BULLETIN NO. 3

Date: August 14, 2018

Dillon Stadium – Phase 2, Hartford, CT

NORTH BLEACHER FOUNDATION PLAN
 SCALE: 1/16"=1'-0"

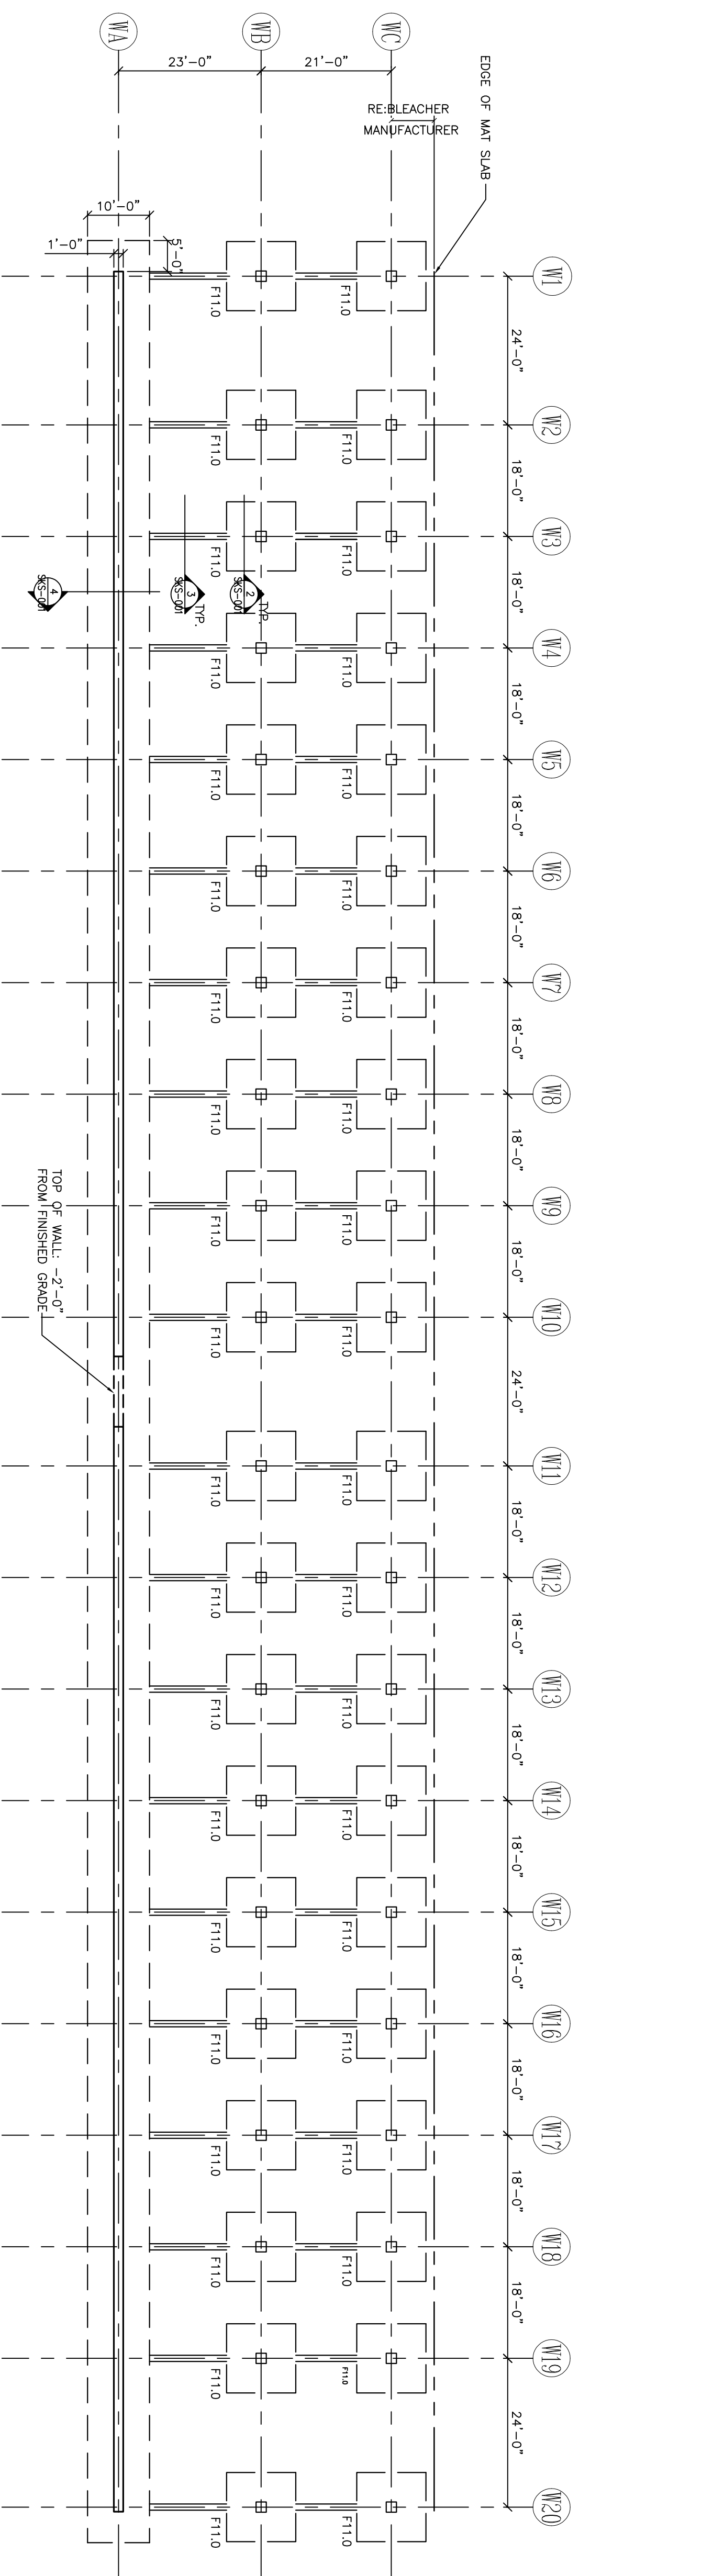
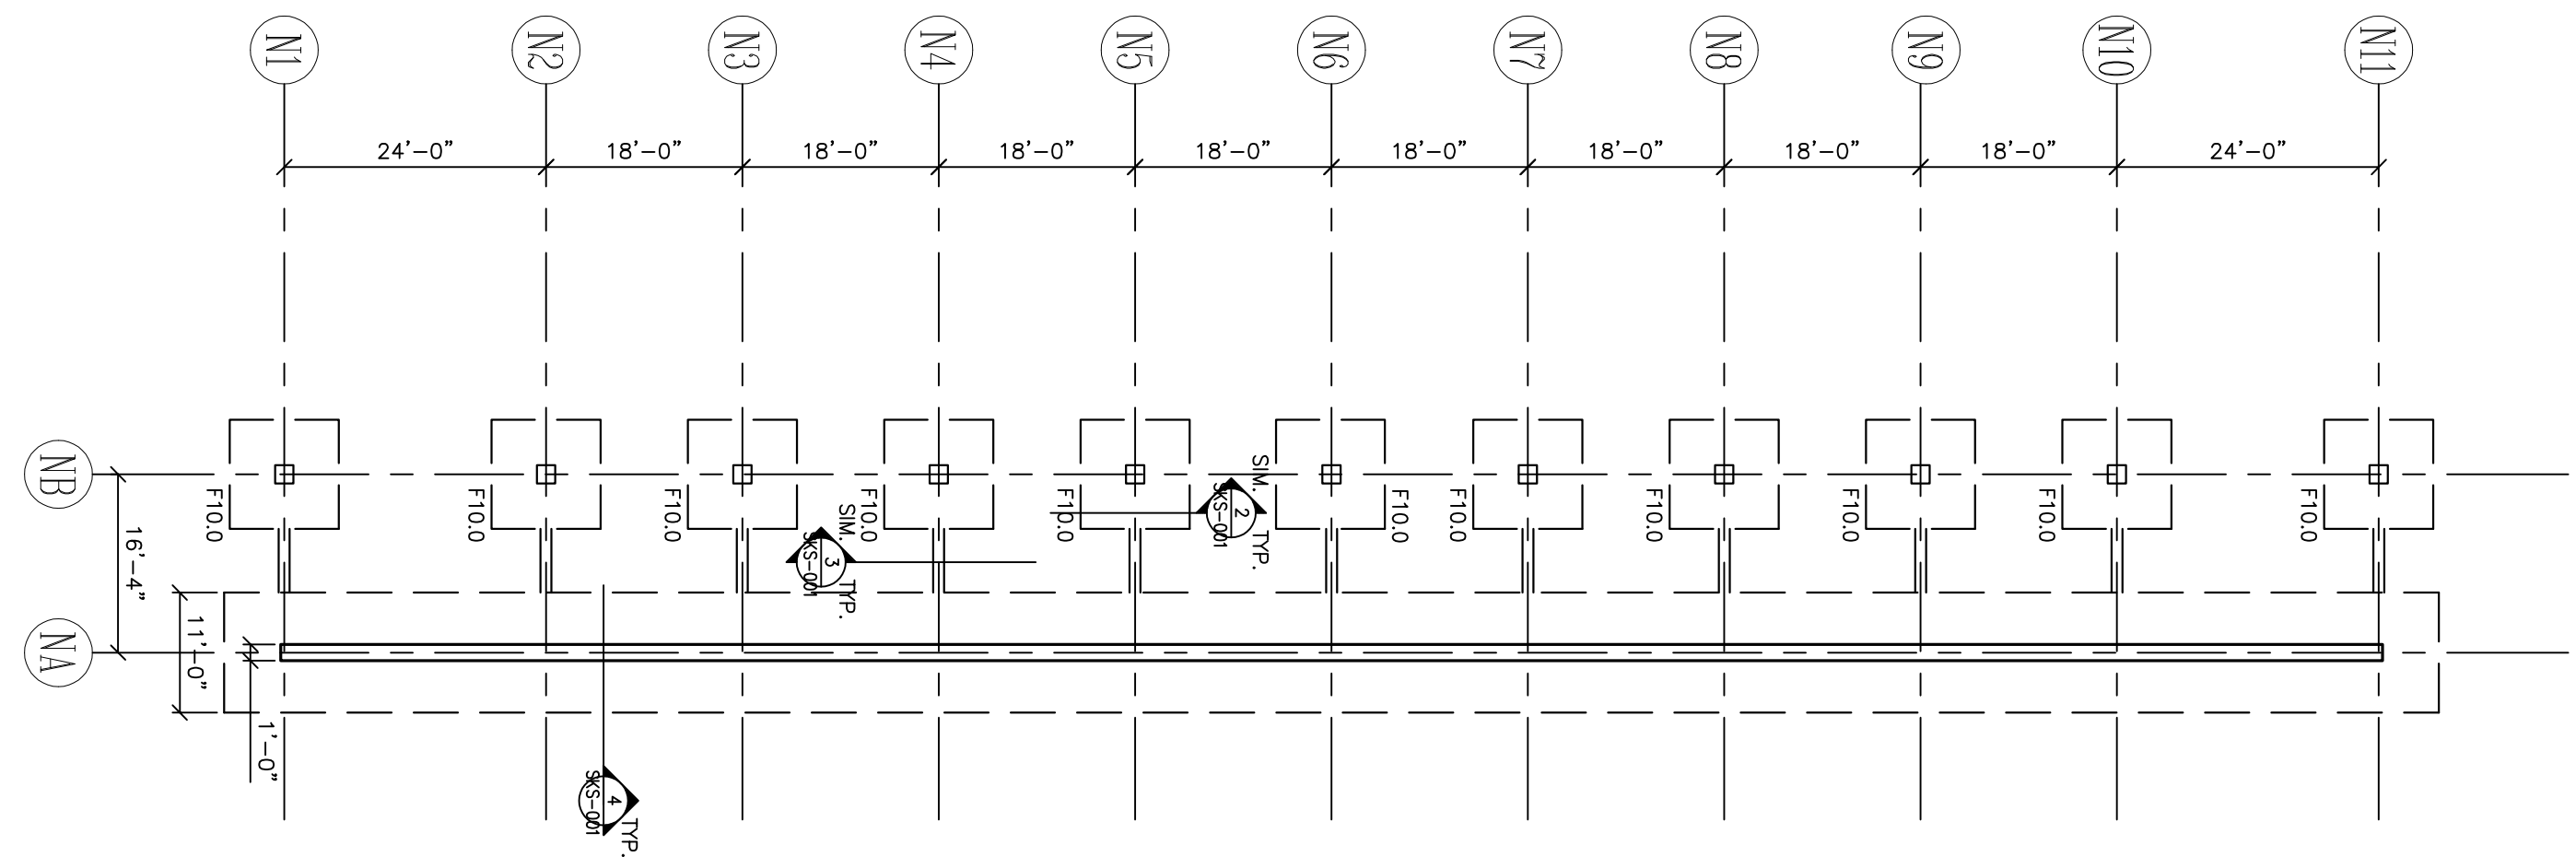
1. **The bid date, place and time are unchanged by this bulletin.**
2. Section 002400 Bid Packages, Part A, Bid Package 2.1 Site Construction, Part B, Bid Package 2.2 Concrete, Bid Package Notes.
Add Note A3.01: Drawing SKS-001 has been revised to include North bleacher foundations. Include this work as an add alternate. The Concrete Contractor shall be responsible for all concrete work at the North Bleacher Foundations. Reinforcing steel including bricks, setup bars and dowel bar subs will be furnished and delivered by others. The Concrete Contractor shall verify quantities and details, coordinate deliveries, off load and install all reinforcing steel required for this scope of work. Furnish and install any incidental rebar required. Anchor bolts will be furnished by others and installed by the Concrete Contractor.
Add Note A3.02: The mud slab and stone under all bleacher foundation footings per Foundation Note 5 on SKS-001 shall be the responsibility of the Site Construction Contractor.
